SERVICE BULLETIN: 02001-2

Date 01/30/02

SERVICE BULLETIN: 02002-3

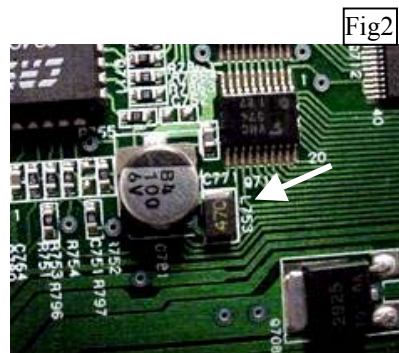
In some units Q713 IC, brand **ISSI**, IS62LV1024LL-70H was used [Fig1], where as in some NEC MPD441000LGU-B70X may be found. For those units using the **ISSI** SRAM and having the above aforementioned problem, you will need to replace the IC Q713 with PN#22241793R3 having NEC MPD441000LGU-B70X or Mitsubishi M5MV108DKV-70H brand label. If above part is to be replaced L753 need not be replaced. See Note.

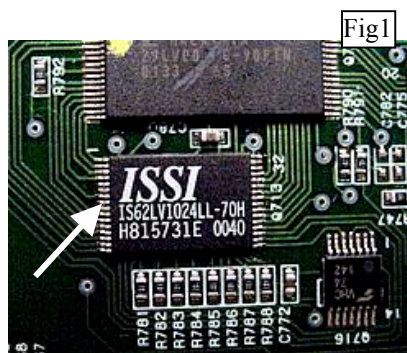
For units having not developed such problem and has the **ISSI** IC in place, it is highly recommended that L753 [Fig2] be changed to 33Ω (PN#433223304R1) chip resistors and need not replace IC.
